CMA PRODUCT IMPROVEMENT

Effective Date: SEPTEMBER 1, 2014
Log Number: CMA-PI-454
Subject: CMA START - RINSE ACTIVATION SYSTEM AND DOOR SAFETY SWITCH
Models Affected: EST 44 AND 66 CONVEYORS

CMA Conveyor Start-Rinse System

**Model EST-66
And
Model EST-44**

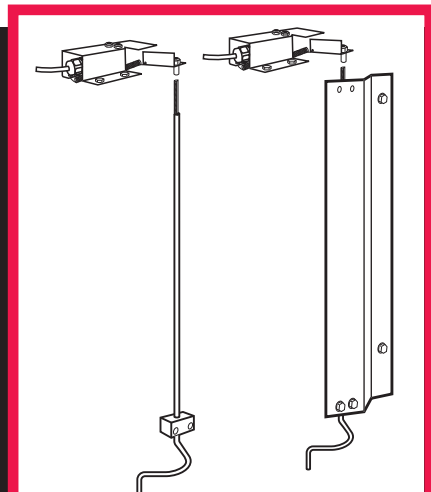
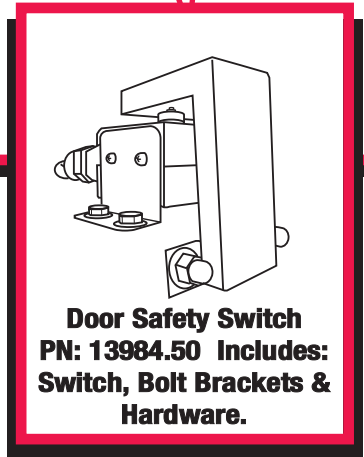
In being proactive, CMA has engineered an innovative way of activating the Conveyor and Rinse System on the EST Conveyors. The Reed Switch Activation System will be replaced with an electro-mechanical Switch and Rod System, which requires no adjustments and is not affected by sensitive adjustment parameters, commonly associated with reed switch and magnet assemblies. The new system incorporates a paddle that is tripped by the dishrack that turns a rod, pushing the Mechanical Push Button Switch.

CMA Conveyor Start-Rinse System Field Kit
PN: 13978.00 (R-L)
PN: 13979.00 (L-R)

Door Safety Switch
PN: 13984.50 Includes:
Switch, Bolt Brackets & Hardware.
